ND-17-1495
10 CFR 50.90

Southern Nuclear Operating Company
Vogtle Electric Generating Plant Units 3 and 4
Request for License Amendment Regarding Effect of Rod Shadowing on Excore Power Range
Detectors, Changes to Nuclear Overpower Reactor Trips, and Changes to Monitoring of
Moderator Temperature Coefficient and Core Power Distribution (LAR-17-031)

Vogtle Electric Generating Plant (VEGP) Units 3 and 4

Figure 15.4.2-~~13~~19
Minimum DNBR Versus Reactivity Insertion Rate for
Rod Withdrawal at 100-percent Power

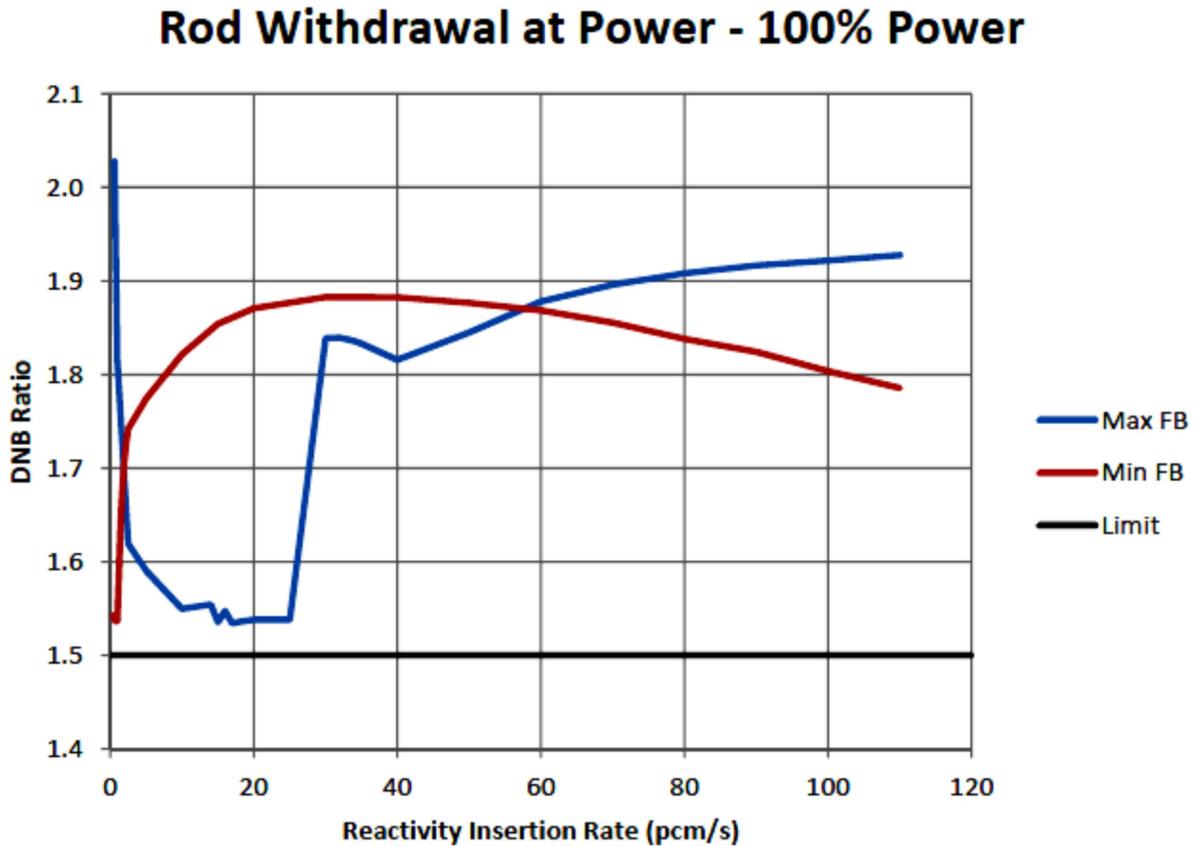
- g. The existing sixth paragraph becomes the new eighth paragraph, and the first sentence is revised to state: “Referring to Figure 15.4.2-19, it is noted that for transients initiated from full power, three reactor trip functions provide the DNB and overpower protection over the range of reactivity insertion rates analyzed. The overtemperature ΔT trip provides DNB protection except for rapid power excursions. The overpower ΔT trip provides protection for the slow to moderate power excursions. The power range high positive flux rate trip prevents both overpower and low DNBR for rapid power excursions.”

22. UFSAR Figure 15.4.2-13 for Minimum DNBR Versus Reactivity Insertion Rate for Rod Withdrawal at 100-percent Power is renumbered as UFSAR Figure 15.4.2-19 and updated to reflect the latest analysis results.

Referring to ~~Figure 15.4.2-14, for example~~15.4.2-19, it is noted that: for transients initiated from full power, three reactor trip functions provide the DNB and overpower protection over the range of reactivity insertion rates analyzed. The overtemperature ΔT trip provides DNB protection except for rapid power excursions. The overpower ΔT trip provides protection for the slow to

Figure 15.4.2-1420
Minimum DNBR Versus Reactivity Insertion Rate for
Rod Withdrawal at 60-percent Power

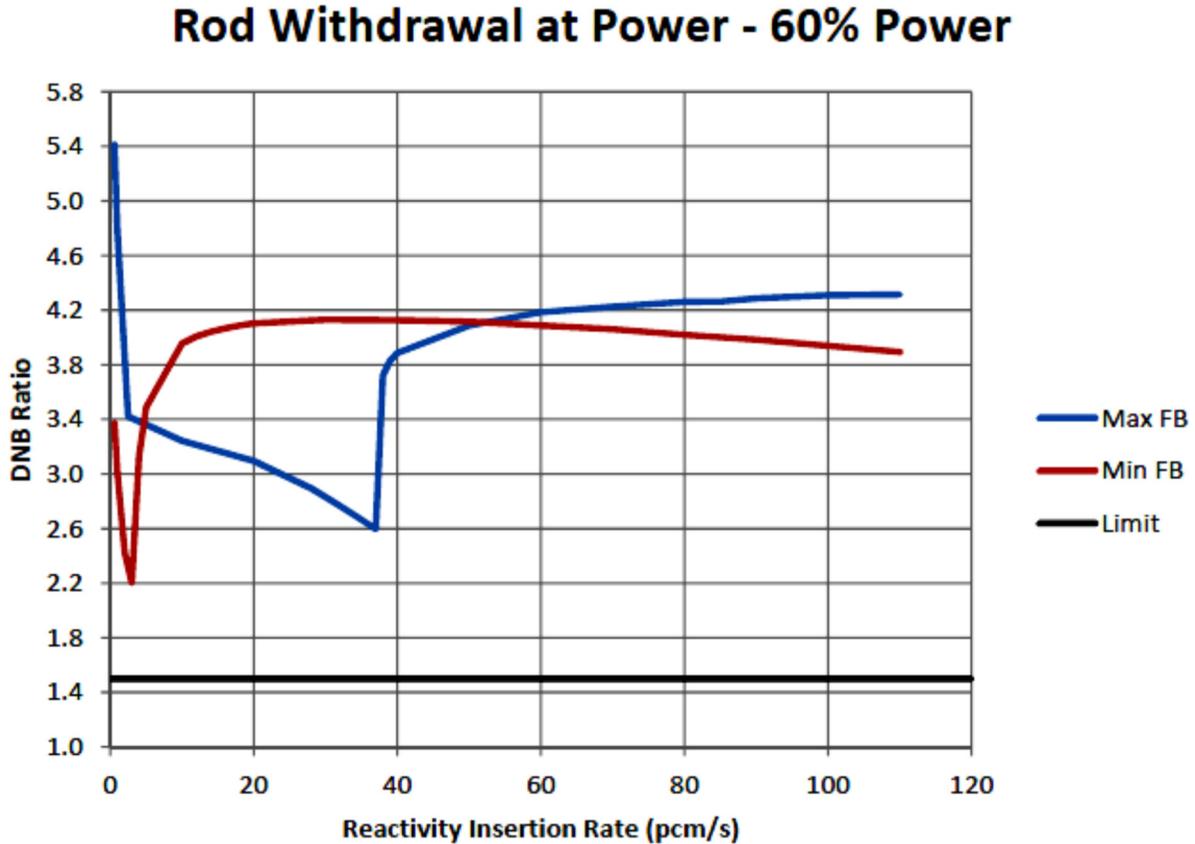
23. UFSAR Figure 15.4.2-14 for Minimum DNBR Versus Reactivity Insertion Rate for Rod Withdrawal at 60-percent Power is renumbered as UFSAR Figure 15.4.2-20 and updated to reflect the latest analysis results.

Figure 15.4.2-~~15~~21
Minimum DNBR Versus Reactivity Insertion Rate for
Rod Withdrawal at 10-percent Power

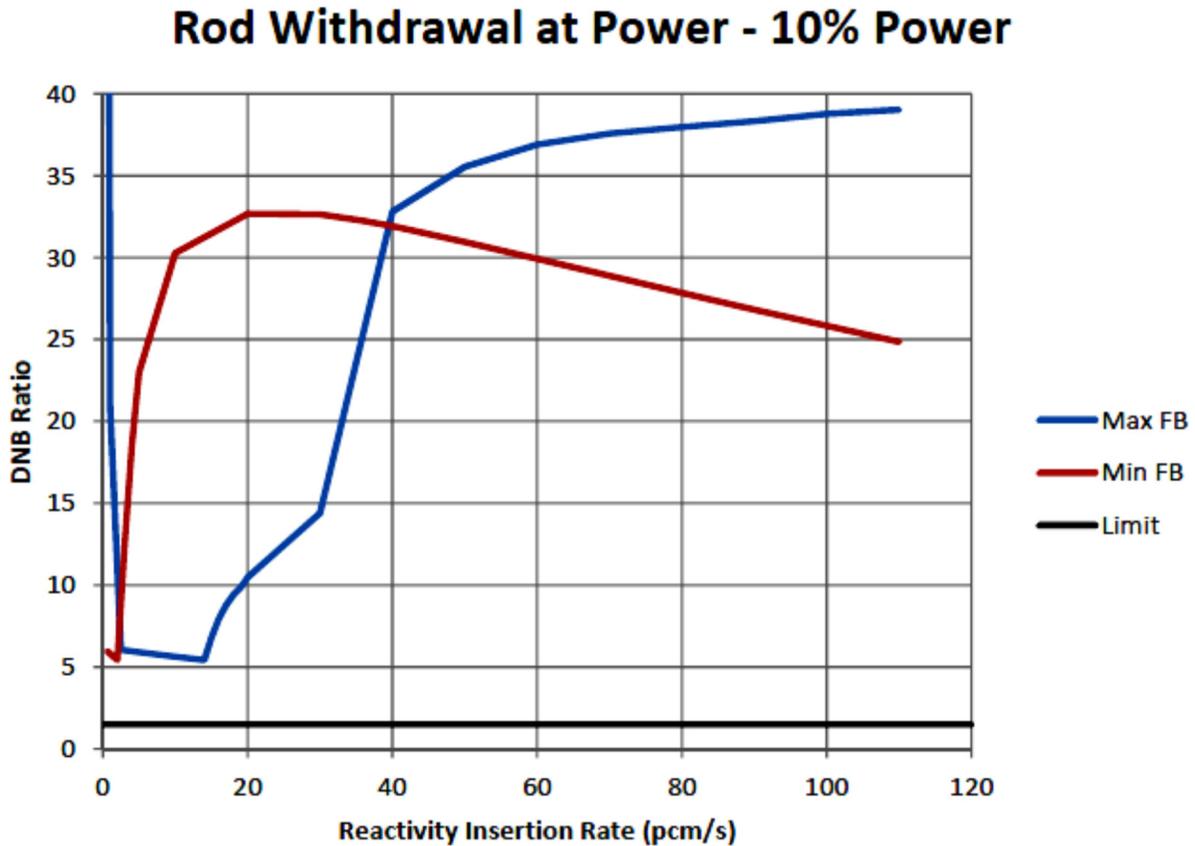
24. UFSAR Figure 15.4.2-15 for Minimum DNBR Versus Reactivity Insertion Rate for Rod Withdrawal at 10-percent Power is renumbered as UFSAR Figure 15.4.2-21 and updated to reflect the latest analysis results.
